## ADDENDUM 02 SOFTBALL UPGRADES

Date: Wednesday, December 3, 2025

Project #: 0323.25.002

Project Name: Softball Upgrades  
Vicksburg High School – 3701 Drummond St., Vicksburg, MS 39180  
Warren Central High School – 1000 MS-27, Vicksburg, MS 39180

**E141**

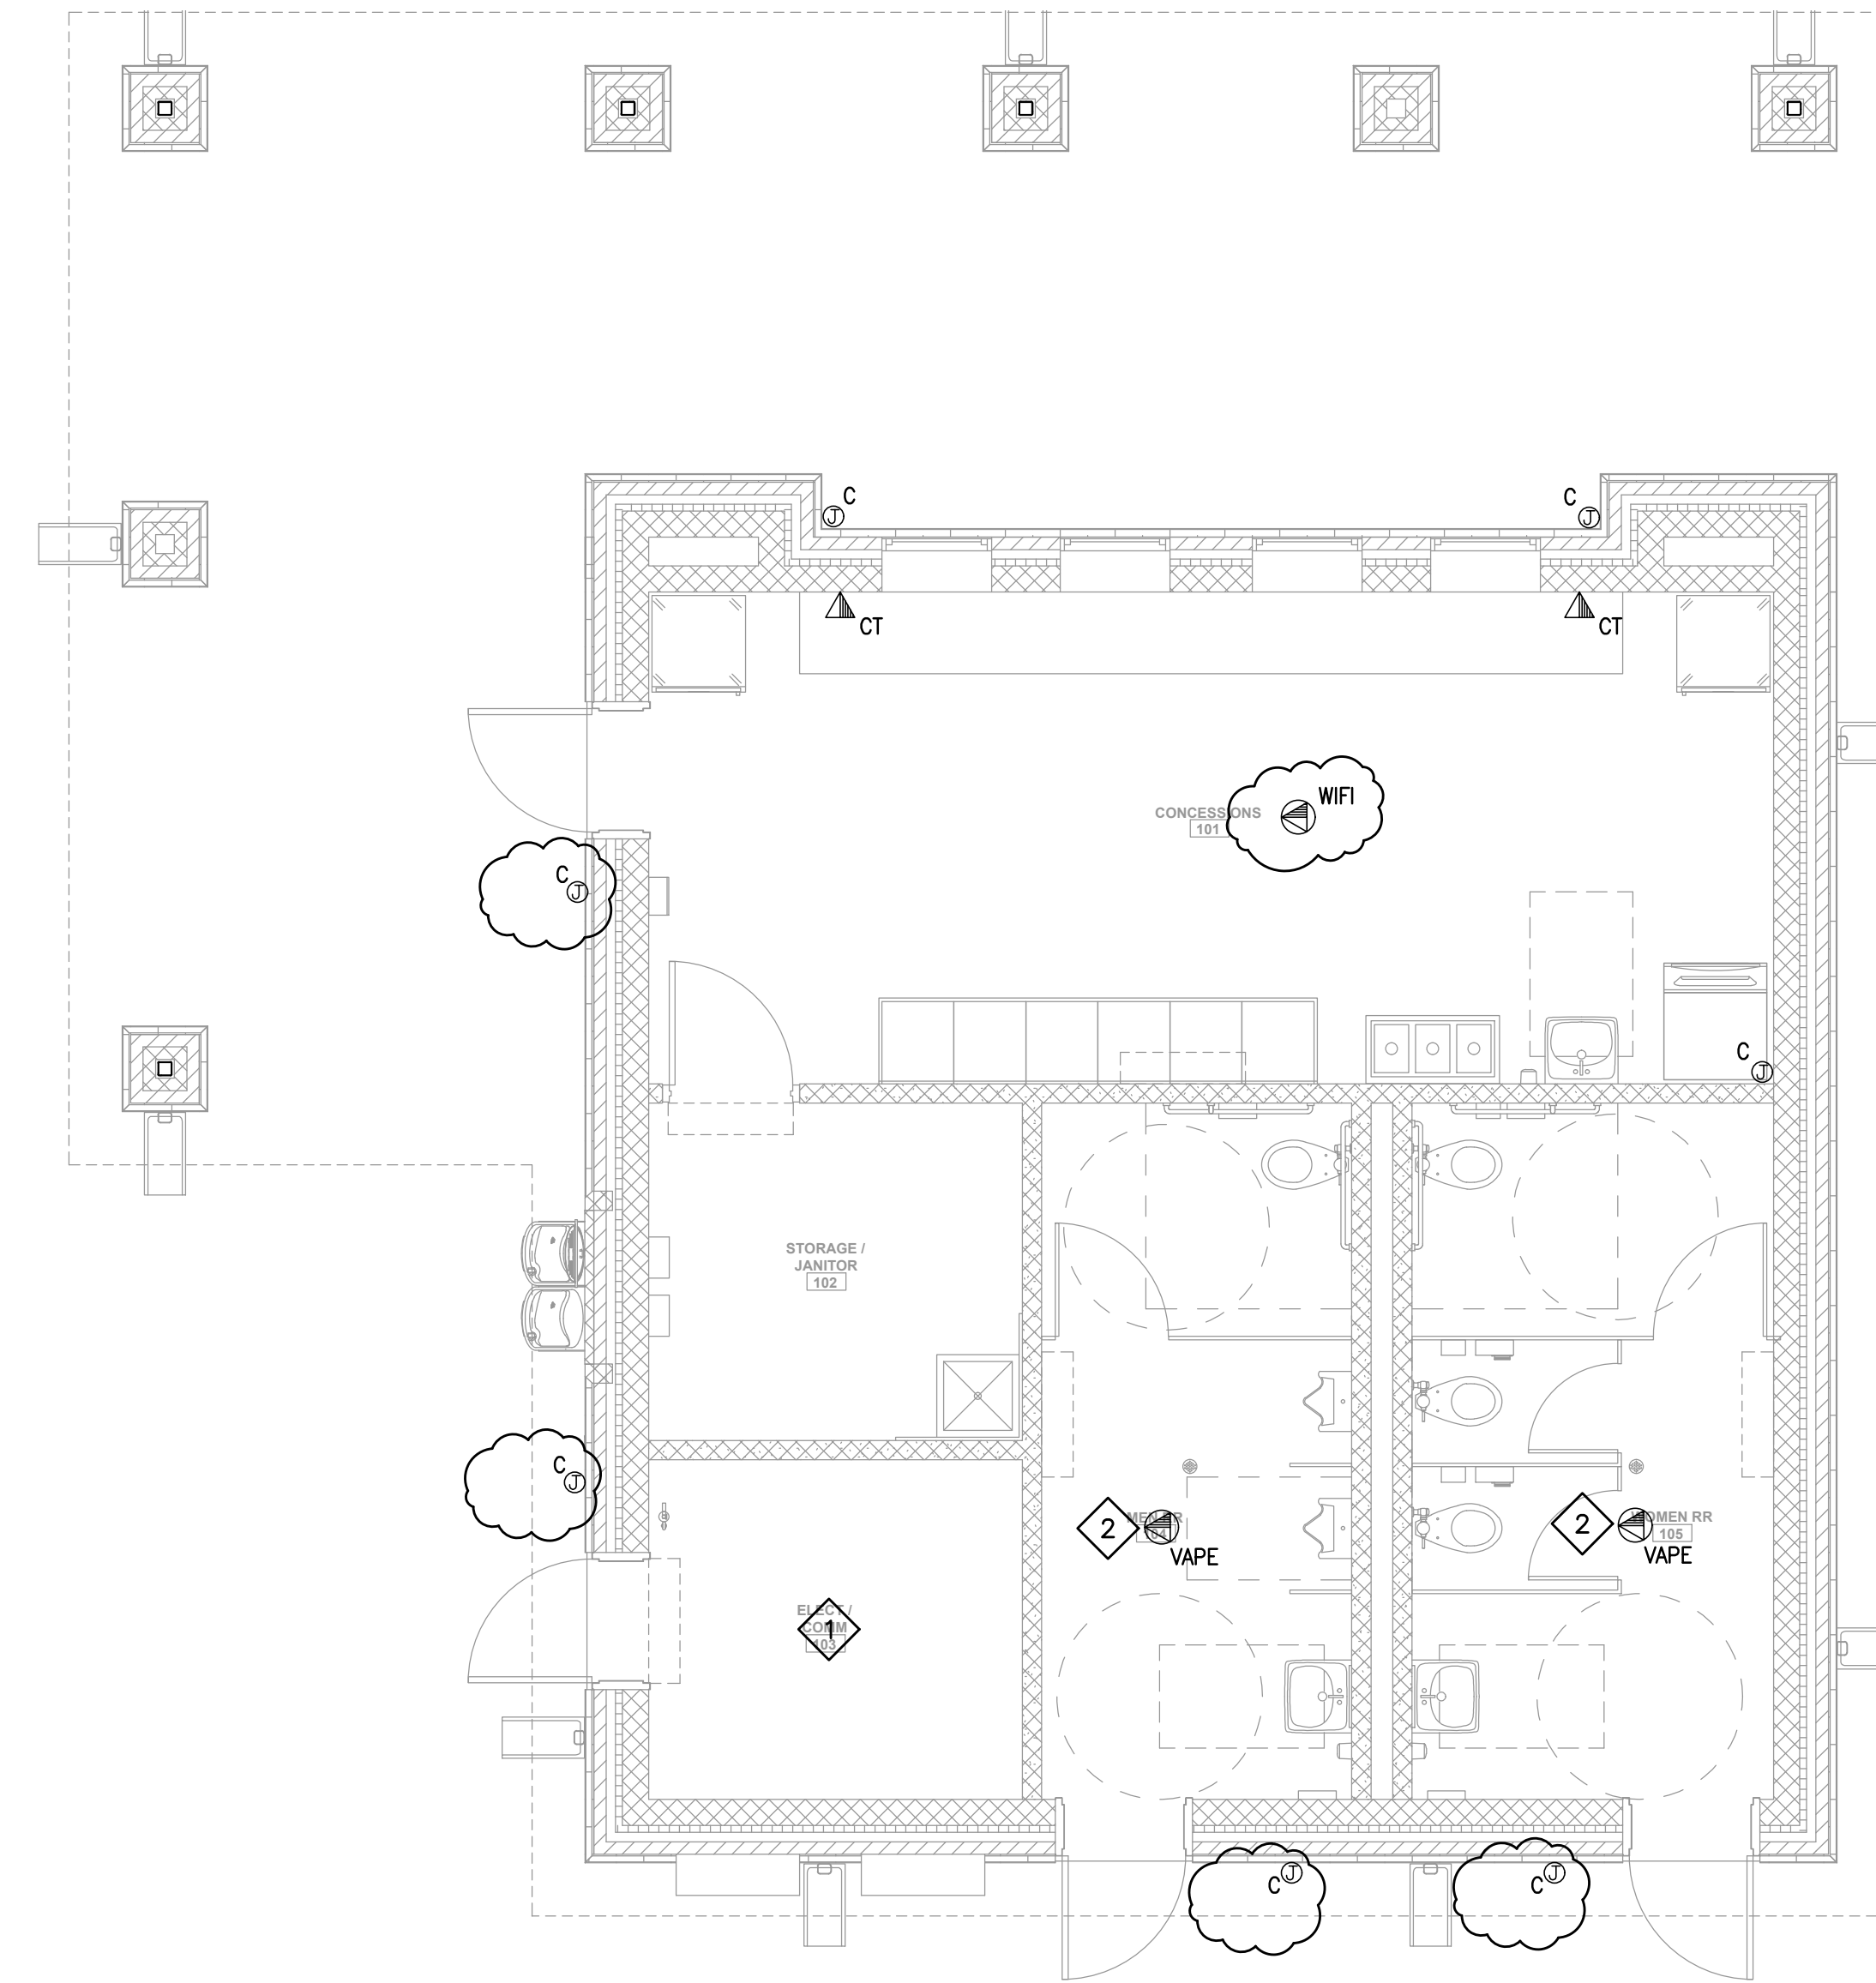
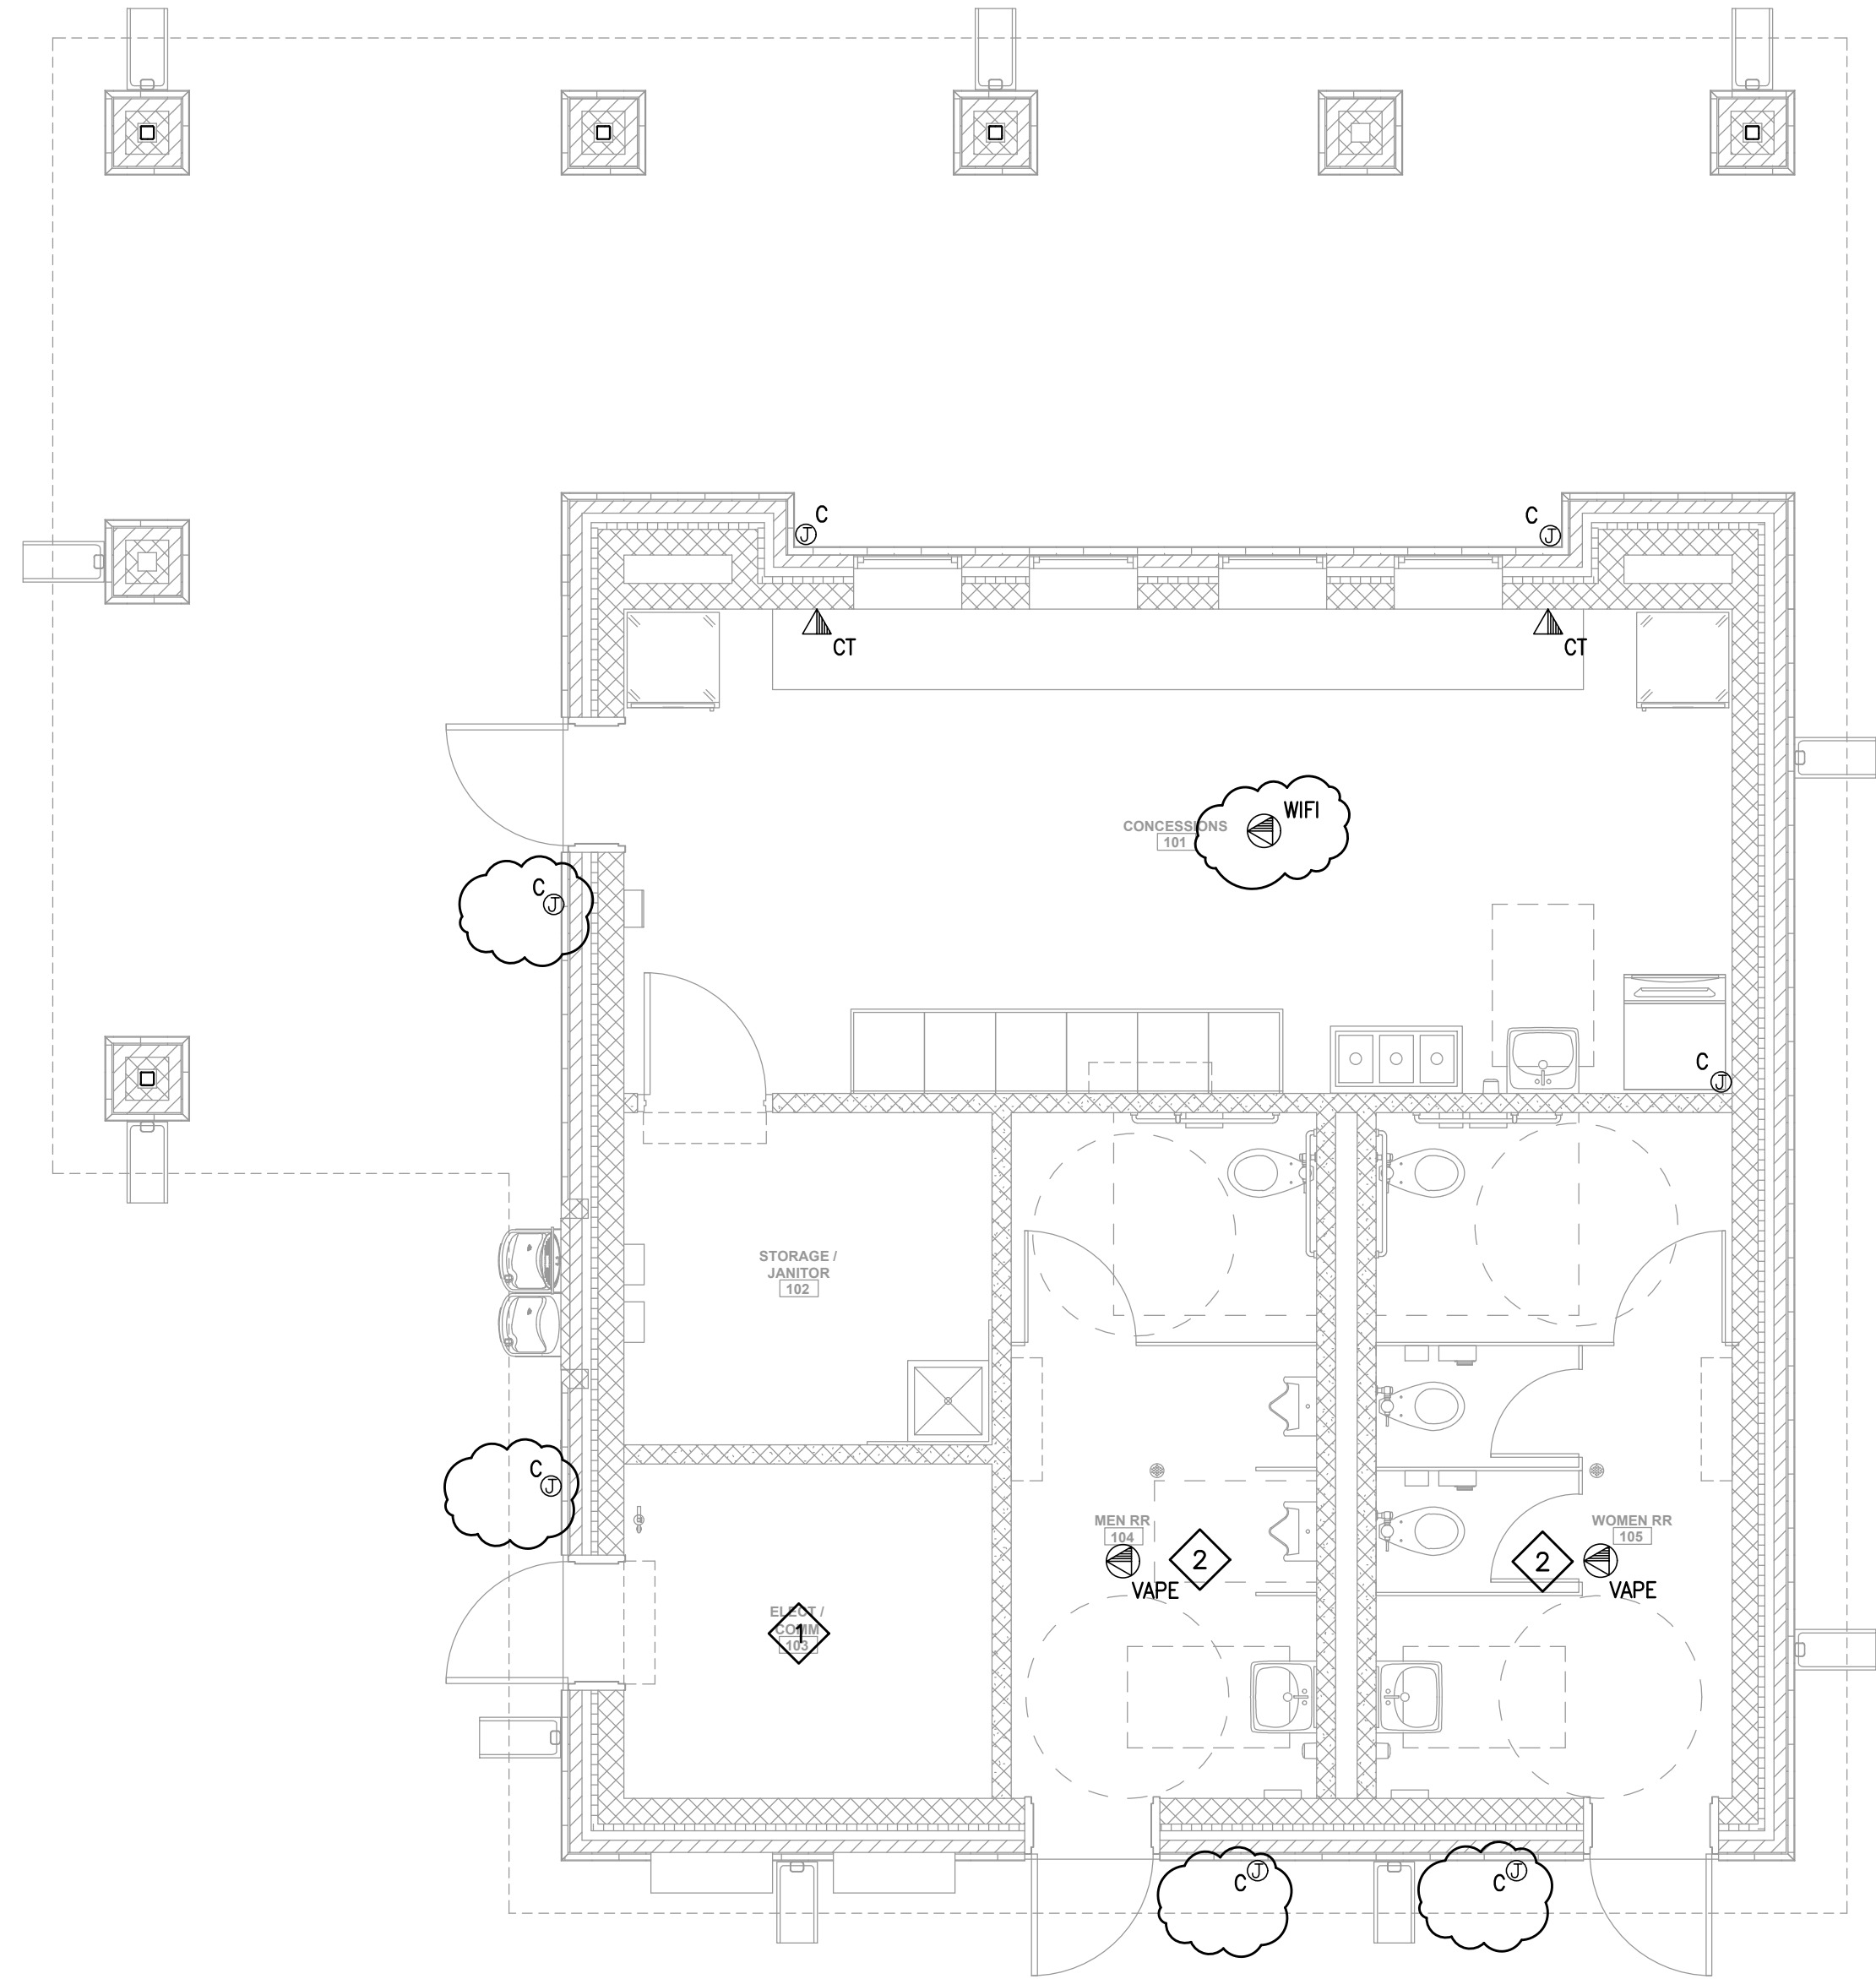
- B2. E141 Note 3 mentions fire alarm components & fire alarm contractor, are there fire alarm systems in the concession stands? **Note 3 on sheet E141 removed under this addendum.**
